| ASSESSMENT REPORT | | | |
|---|---|-----------|-------------|
| Unique Document ID and Revision No: | ONR-OFD-AR-17-009 Revision 0 | TRIM Ref: | 2017/189621 |
| Title: | Torness (TOR) Reactor 1 (R1) 2017 Periodic Shutdown – Assessment of the results of the Graphite Core Inspections | | |

Torness Reactor 1 2017 Periodic Shutdown – Assessment of the results of the Graphite Core Inspections

> Assessment Report ONR-OFD-AR-17-009 Revision 0 24 May 2017

Figure 1: TOR R1 2017 Peripheral Inspection Coverage.

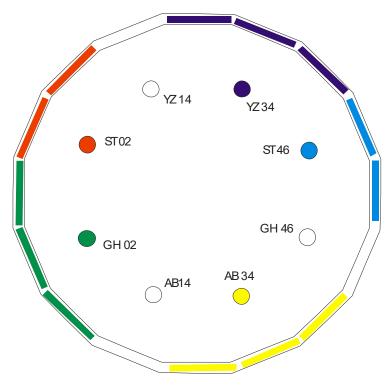
- 12. Inspection of 13 out of 16 faces, see Figure 1, of the peripheral shield wall at TOR R1 found 25 cracked bricks which extrapolates to a total of 31 cracked bricks for the entire peripheral shield wall, approximate to 1.6% cracked bricks, if the incidence of cracking is uniformly distributed.

- 42. I consider NGL, having inspected 13 out of 16 faces of the peripheral wall, has now characterised the condition of the peripheral bricks in TOR R1 with sufficient confidence. I consider it provides a well-established baseline for future inspections on TOR R1, which would enable NGL to gain a much clearer understanding of the damage progression at TOR R1.

Figure 2: Left: Branched Crack in a Corner Peripheral Brick in **TOR R1**; found via route C50, penetration YZ34. Right: Significant Branched Crack found in a Corner Peripheral Brick in **TOR R2** 2015.

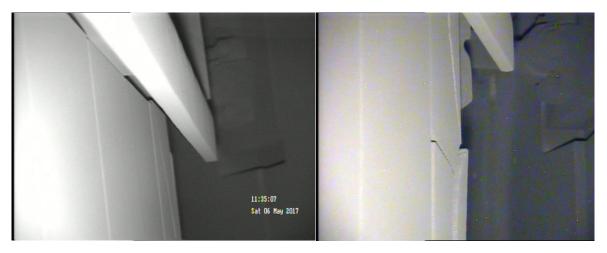
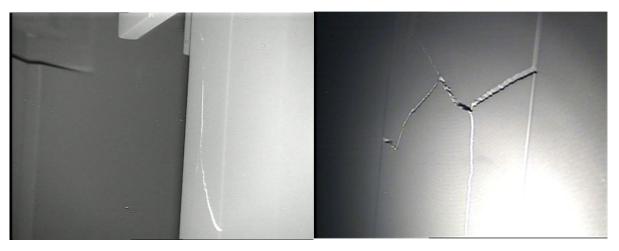
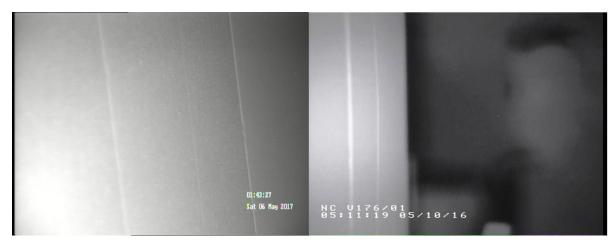
- 13. Overall, NGL claims that the observed cracking is broadly consistent with that seen in TOR R2 2015 and HYB R8 2016 where approximately 1.5% and 2.1%, respectively, of peripheral shield wall bricks were determined to have cracked. However, when examining closely the morphology of the cracks, it is evident that the TOR R1 findings show more similarity to HYB R8 than to TOR R2.
- 14. Out of the 25 cracks found in TOR R1, only three are pronounced cracks found in the corner bricks which exhibit certain level of similarity to TOR R2, albeit not as severe, see Figures 2, 3 and 4. Other cracks however, are fairly tight, straight and mostly located in the mid-face of the brick (see Figure 5), which bears close similarity to the HYB R8 2016 findings.

- 37. I have observed that the cracks found in TOR R1 bear close similarity to those in HYB R8, and some, although not as severe, exhibit resemblance to the branched cracks in TOR R2. However, most importantly, I consider that the percentage of cracking of 1.6% demonstrate consistency with the 1.5% cracked bricks found in TOR R2 2015 and 2.1% in HYB R8 2016.

Figure 6: Restraint Structure showing Peripheral shielding bricks and Gas Coolant Flow

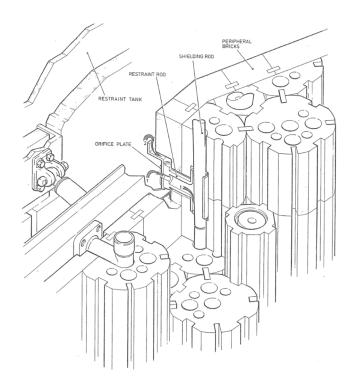
- 17. The core restraint arrangement is shown in Figure 6. Steel restraint rods pass through the peripheral shielding bricks at each interlayer position. Short steel cylinders, or inserts, are mounted on the ends of the restraint rods and locate in selected graphite outer reflector bricks. The restraint rods attach to restraint beams forming a sixteen-sided polygon around the core at each interlayer. The beams are loosely connected at their ends by pin joints, as a secondary restraint feature, and their weight is supported through pads which rest on cut-outs in the peripheral shielding bricks. Radial loads from the core are transferred to the restraint tank by two ball-ended restraint links Warwick links. These constrain the core boundary to move radially with the steelwork, whilst at the same time allowing for differential thermal expansion of the graphite core structure and the steel restraint tank in the vertical direction.

- 40. Furthermore, inspection of the core restraints and the measurement of the bow and tilt of edge channels has provided some reassurance that the cause of the peripheral brick cracking is not the gross failure of the core restraints.

Figure 8: Fully circumferential crack found in a layer 8 brick of fuel channel N41 in TOR R1

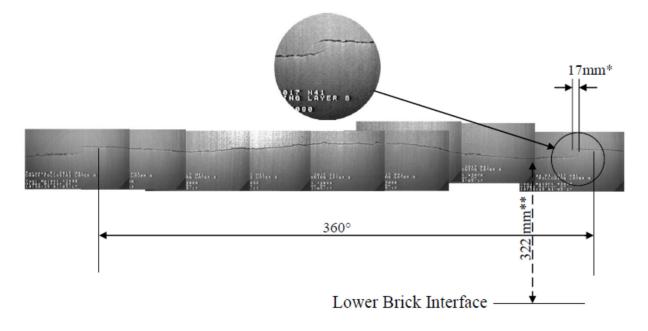
- 4.2.2 Fuel Channel Inspection Findings
- 31. NGL reported that one fully circumferential crack (Type IIIC) was observed in Layer 8 of Channel N41 (Figure 8), which had not been previously inspected. One partial circumferential crack in Layer 5 of Channel C31 had grown to a fully circumferential crack between 2010 and 2017 (Figure 9). All bore shrinkages and channel distortions were however small and within expectations set by NGL [14].

- 43. Inspection of 16 fuel channels in TOR R1 found one fully circumferentially cracked fuel brick (Figure 4) and one partial circumferentially cracked brick in the channels not previously inspected, and a fully circumferentially crack developed from a partially circumferential crack between 2010 and 2017 (Figure 5). These numbers are well below any level that would challenge the safety case and are within NGL's statistical prediction [13]. The core distortion measurements were within expectation and in my opinion consistent with the expected slow progression of irradiation induced dimensional change.
